Supplier Name: Onion Corporation

Onion PCN #: O2S-01

Part Number: OM-O2S, OM-O2SP

Summary of Changes

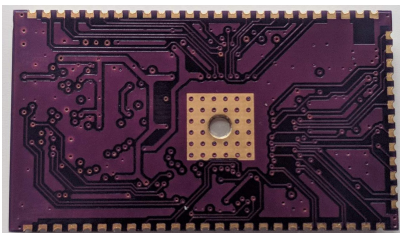
Description of Change: Onion has made slight modifications to the Omega2S product family by adding micro vias to the bottom ground pad of the PCB. This change has no electrical or functional effect on the product.

Reason for Change: With this change Onion expects to improve the unit's heat dissipation through the PCB bottom ground pad.
